FOR APPROVAL - NMA

Project
43 Wilbury Road
Letchworth Garden City

Drawing
East Yard Gate
(Screen)

Drawing No. 43-GPP-150
Revision 03

GARAGE: EAST ELEVATION

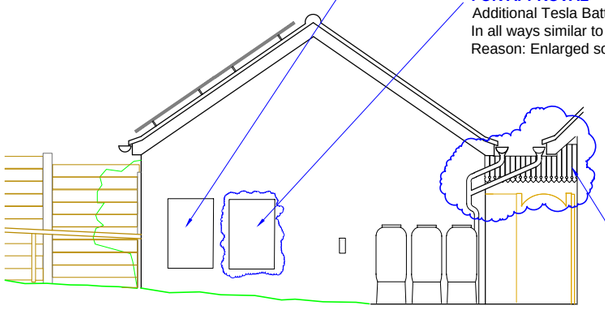
FOR APPROVAL
Additional Tesla Battery Unit adjacent on brick wall
In all ways similar to existing (24-00094-FPH)
Reason: Enlarged solar power storage capacity.

FOR APPROVAL
High level screen across gateway
Maximum height approximately 2400 AGL outside eaves
Reason: Privacy

HOUSE PROPOSED: WEST ELEVATION

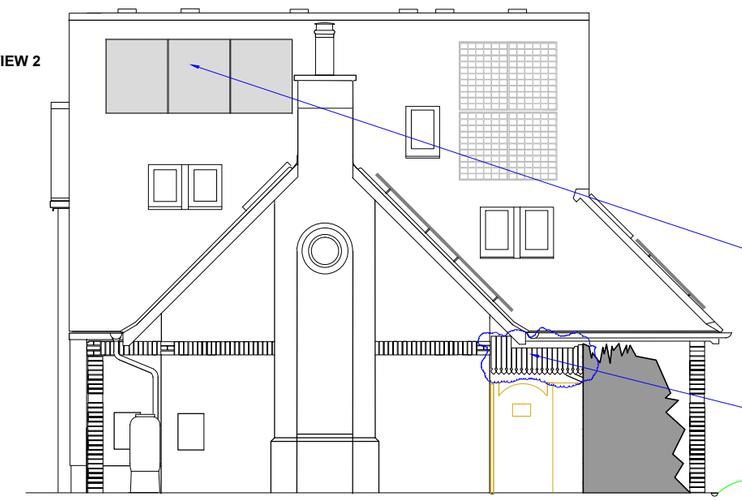
FOR APPROVAL
Screen formed by daggerboard panel
Purpose-made GRP panel, cut to required shape.
Suspended and braced from wall, rafter and gable ladder
Wind relief openings
Black self-colour finish

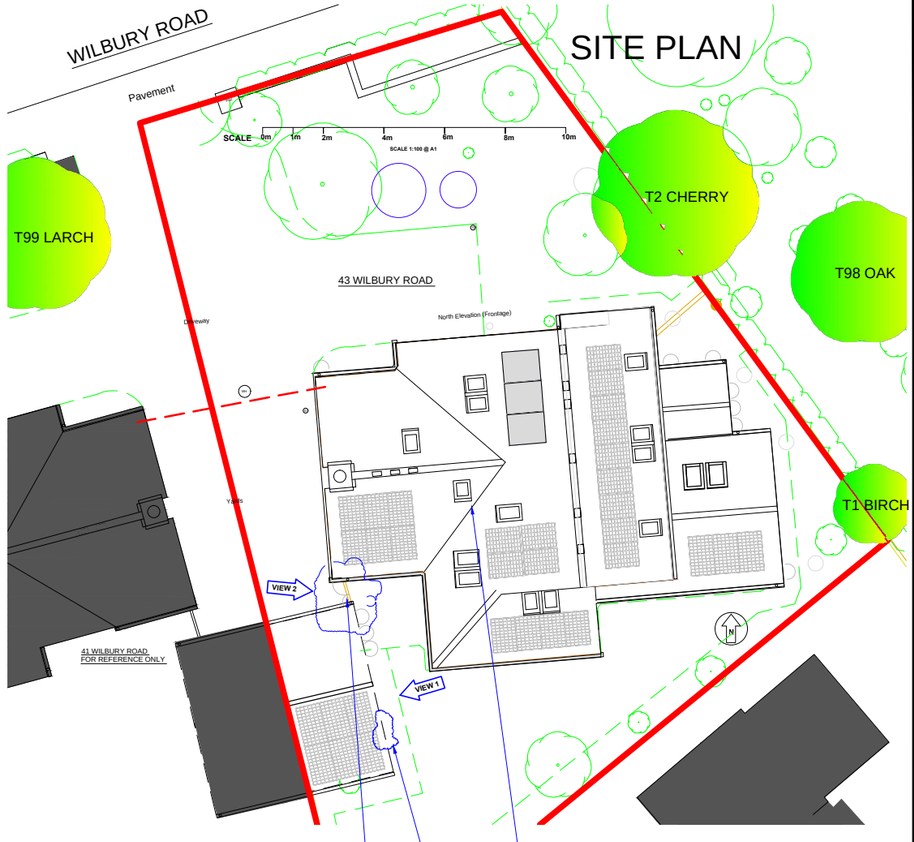
FOR APPROVAL
Additional Tesla Battery Unit adjacent on brick wall

FOR APPROVAL
High level screen across gateway
Screen replaces proposed new gate in 24-00094-FPH
